EL PASO COUNTY
COLORADO

TO: Planning Commission
FROM: Jennifer Irvine P.E. MPA, County Engineer/ECM Administrator
DATE: June 2, 2020
RE: Engineering Criteria Manual (ECM) Revisions

These revisions include a new chapter specific to ADA Accessibility guidelines and the associated revisions throughout the ECM for consistency and updated standard drawings are summarized in the attachments.

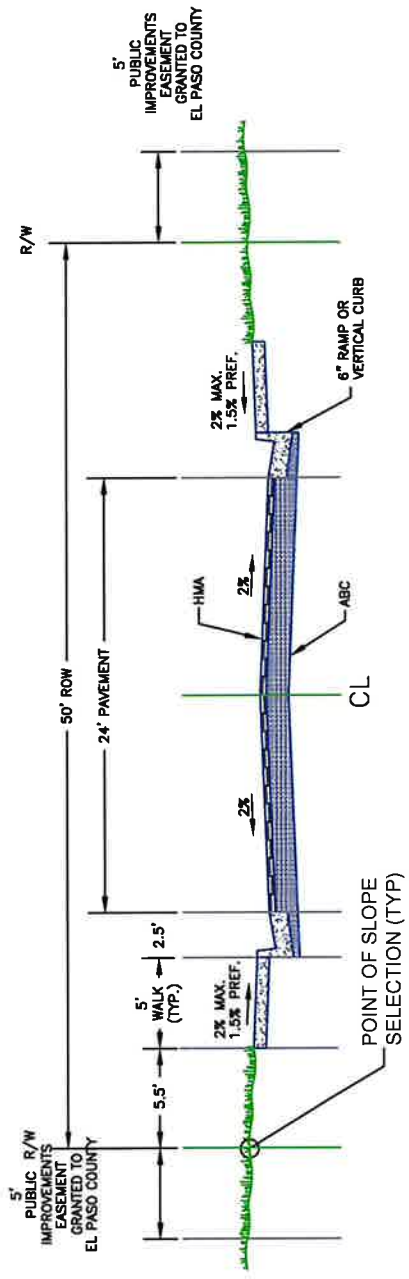
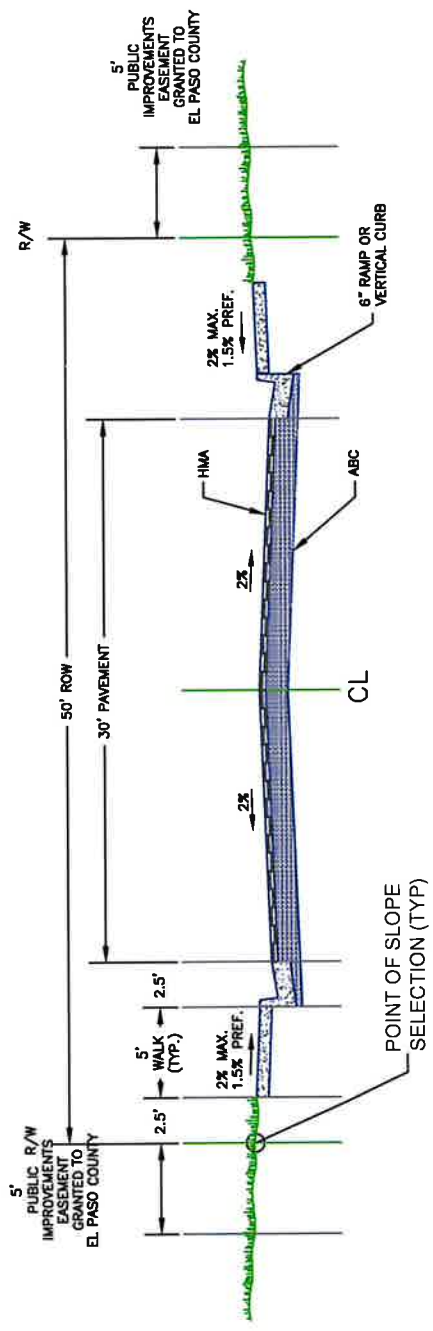
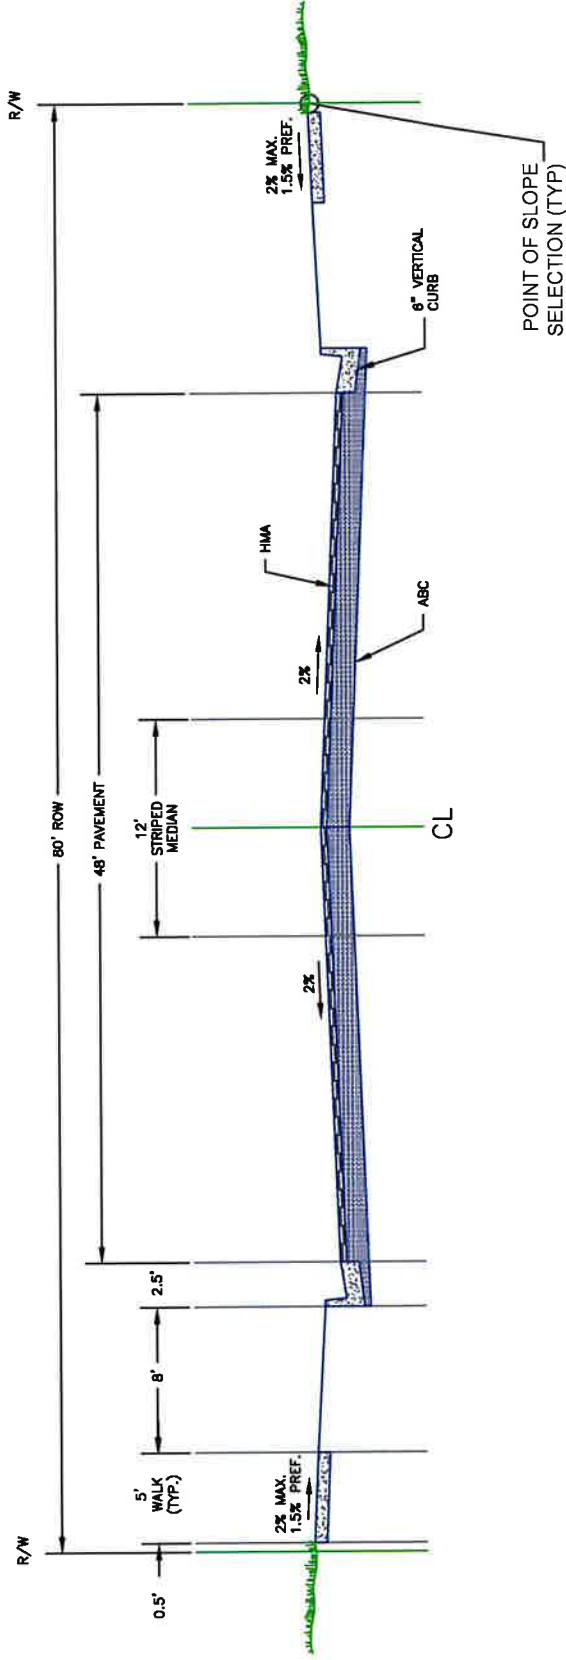
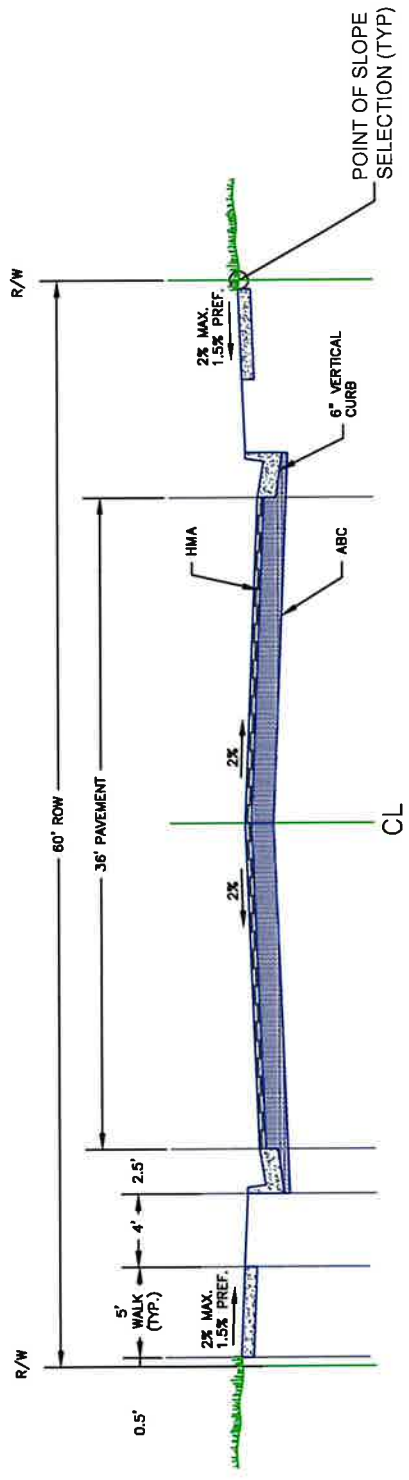
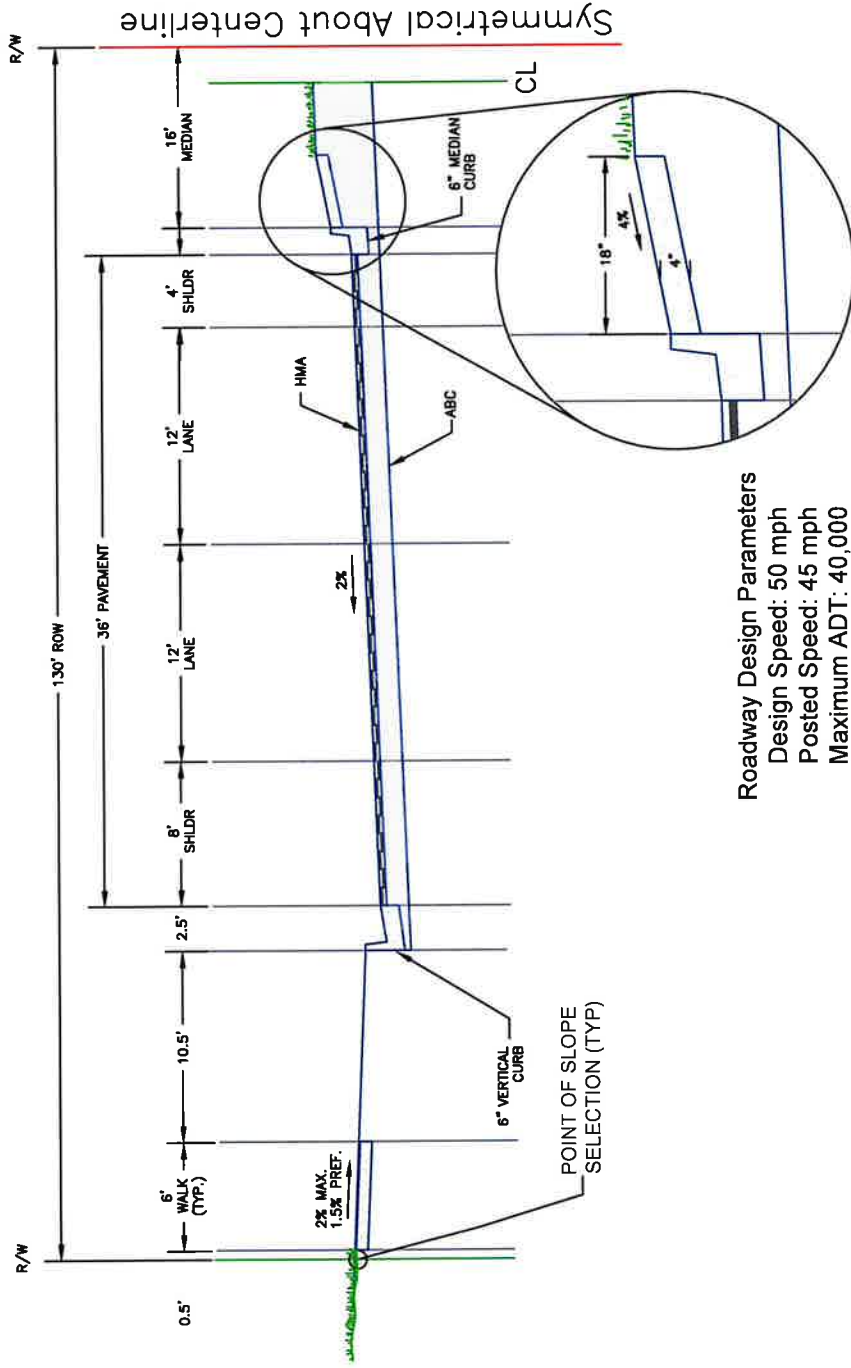
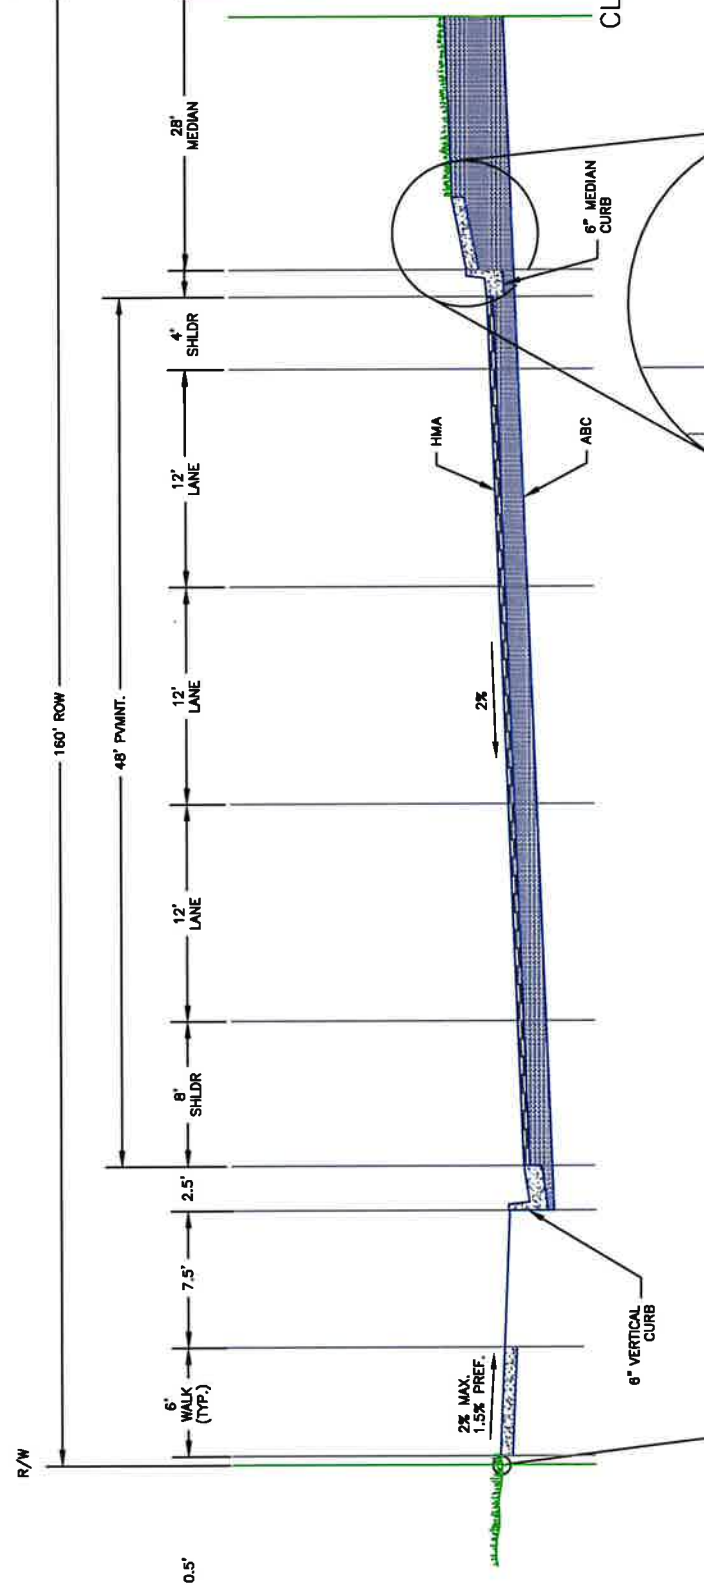
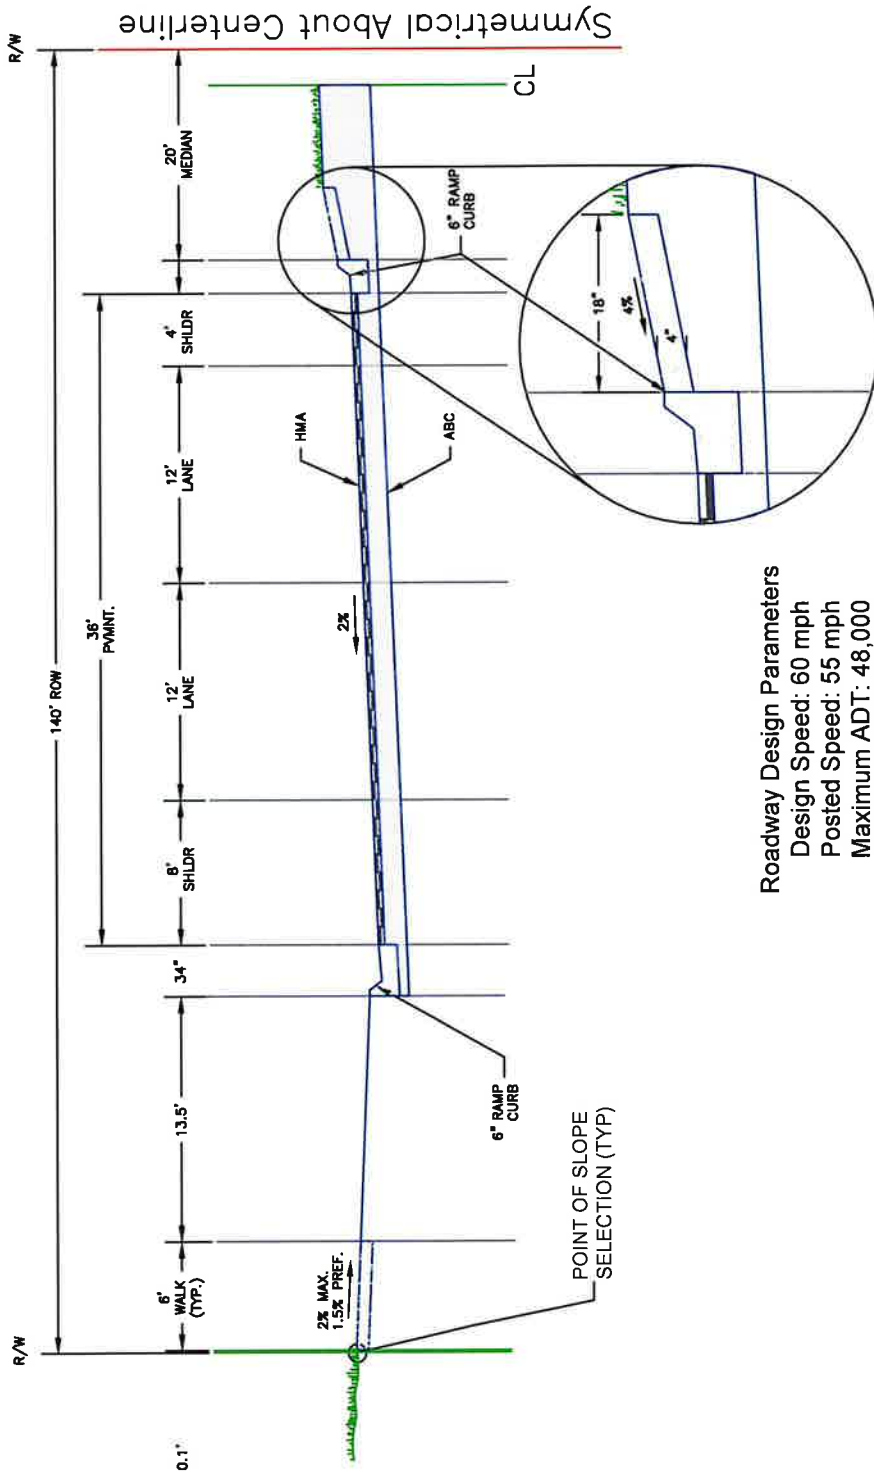
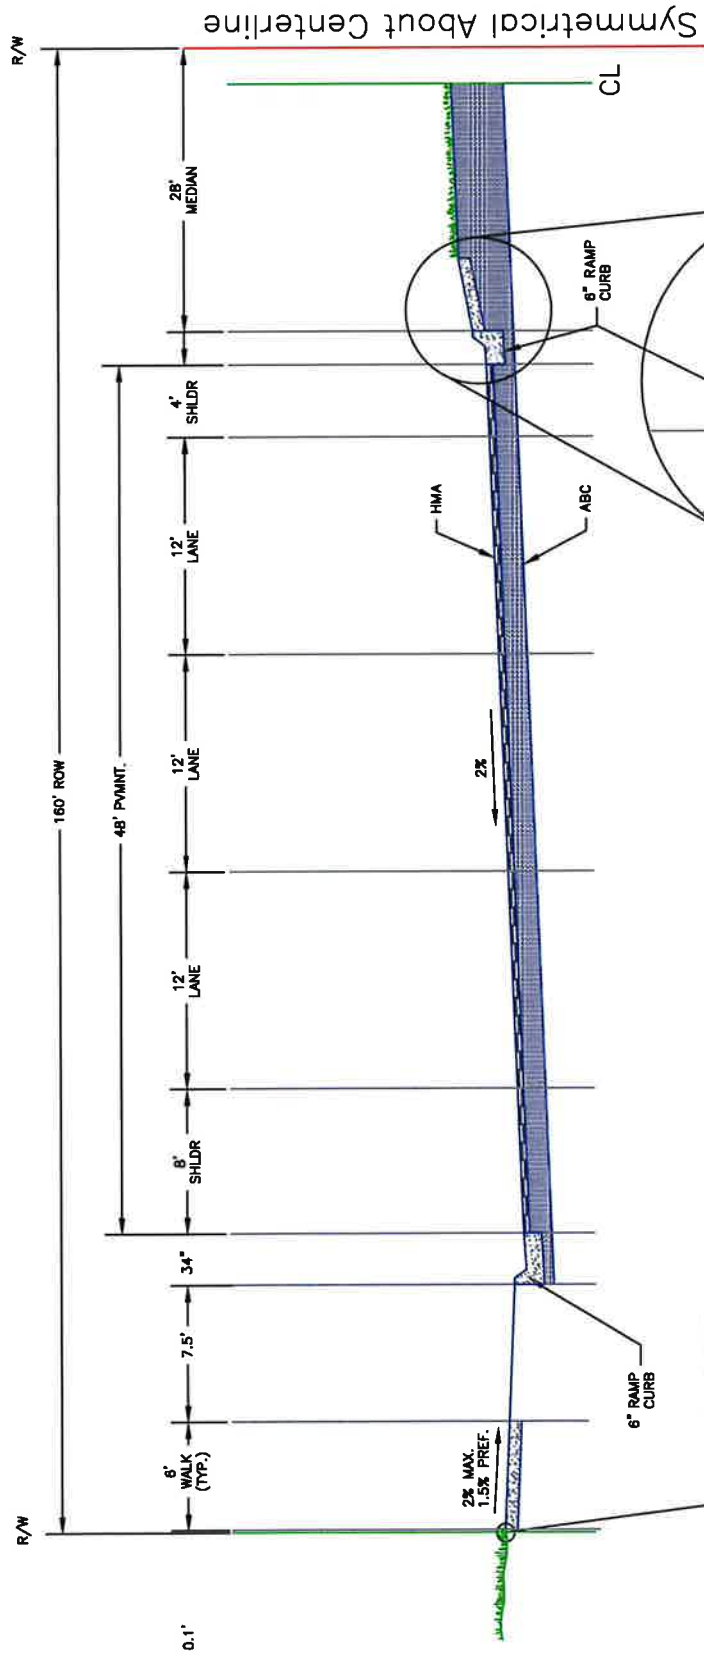
5.10.6.B	5-69	Revise second bullet: "pedestrian facilities and curb ramps"	Expand to include sidewalks and other pedestrian facilities.
ECM Appendix F	SD_2-1 - SD_2-9		Add cross slope over sidewalk as 2% max. (1.5% preferred)	Provide room for construction tolerance.
	SD_2-20		Gutter cross slope exceeds 5%. Add note to flatten at curb ramps Modify to provide 4' min. sidewalk width at the flared portion of sidewalk. Modify cross slope to show 2% max. (1.5% preferred). Add note to comply with ECM Chapter 6.	Required for compliant counterslope at curb ramps.
	SD_2-24		Modify to provide 4' minimum sidewalk width across driveway. Modify cross slope to show 2% max. (1.5% preferred). Add note to comply with ECM Chapter 6.	Provide room for construction tolerance.
	SD_2-25		Add language in ECM Chapter for other ramp designs permitted by PROWAG, and reference/utilize CDOT standard details if they are not found in EPC App F.	Provide room for construction tolerance.

DATE APPROVED: _____ DEPARTMENT OF PUBLIC WORKS		Pedestrian Curb Ramp Detail Standard Drawing		FILE NAME: SD_2-40
6/23/20		REVISION DATE: 6/23/20		FILE NAME: SD_2-40
Jennifer E. Irvine		DEPARTMENT OF PUBLIC WORKS

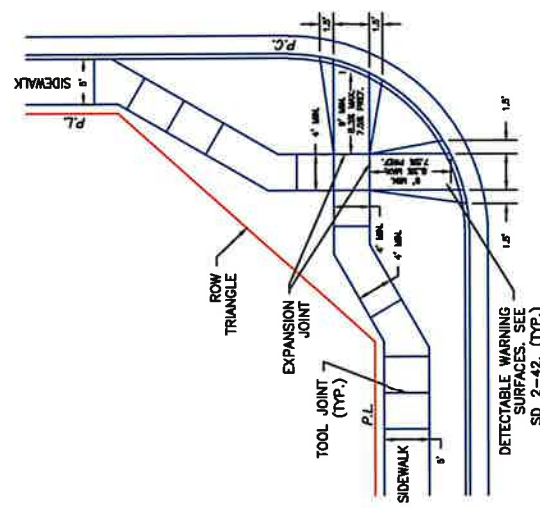
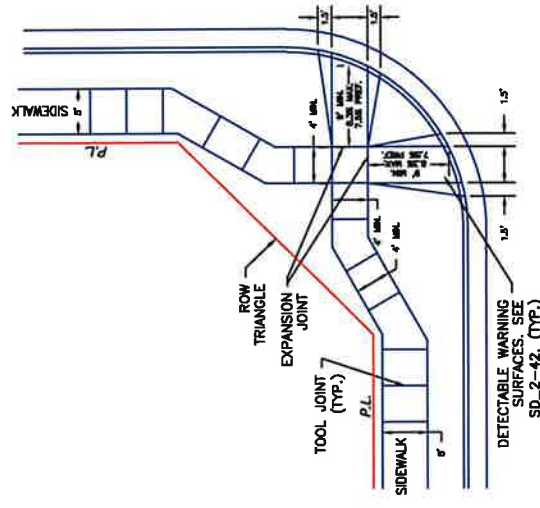
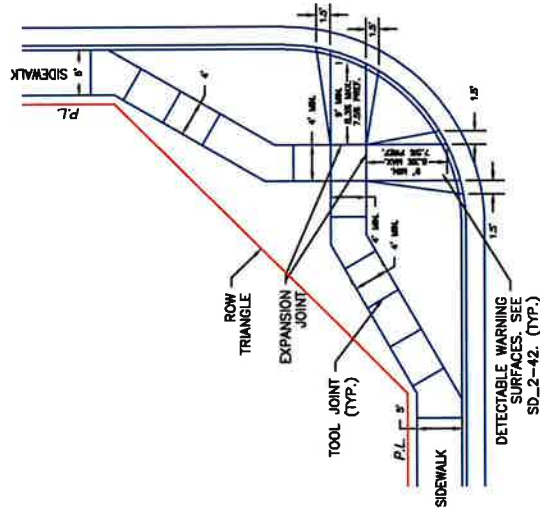
Curb Ramps		Change name to Pedestrian Curb Ramp Detail. Modify to provide 4' min. sidewalk width at the flared portion of sidewalk. Modify cross slope to show 8.3% max. (7.5% preferred). Change name to Detectable Warning Surfaces and refer to SD_2-42.	Utilize current standard drawings, direct designers in ECM to propose other site specific designs if standard designs are not feasible.
	SD_2-40			Recommended

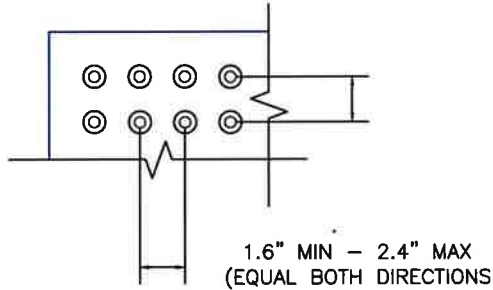
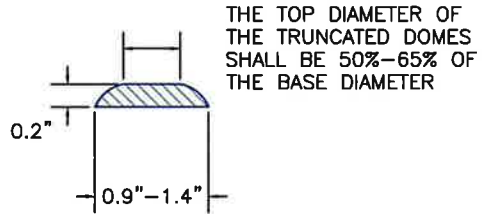
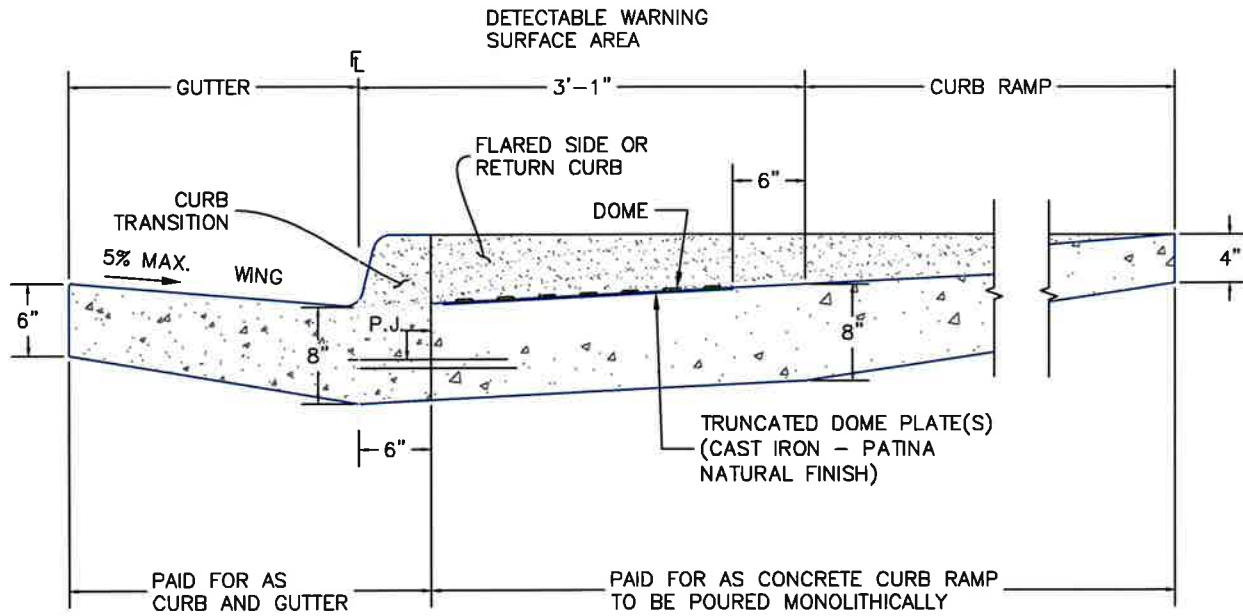
SD_2-41		Modify the DWS standard to be compliant with PROWAG and specify the material to be used as cast iron.	Required
	SD_2-42		Change name to Parallel Pedestrian Curb Ramp Detail. Modify cross slope to show 2% max. (1.5% preferred) for turning space. Modify running slopes to show 8.3% max. (7.5% max preferred). Modify DWS to show cast iron type.	Recommended
	SD_2-50			Recommended
Design Checklists				
			Add design checklists for pedestrian access routes and curb ramps.	Provides designers and contractors with a way to verify their designs meet PROWAG requirements. Checklists will not be included in ECM or required as part of official project file. They will be available as a recommended tool during project development.
EPC Land Dev. Code	5.2.36.D.1.i.	5-49	Add bullet: "Method for accommodating pedestrians" to requirements for Traffic Control Plan	Recommended
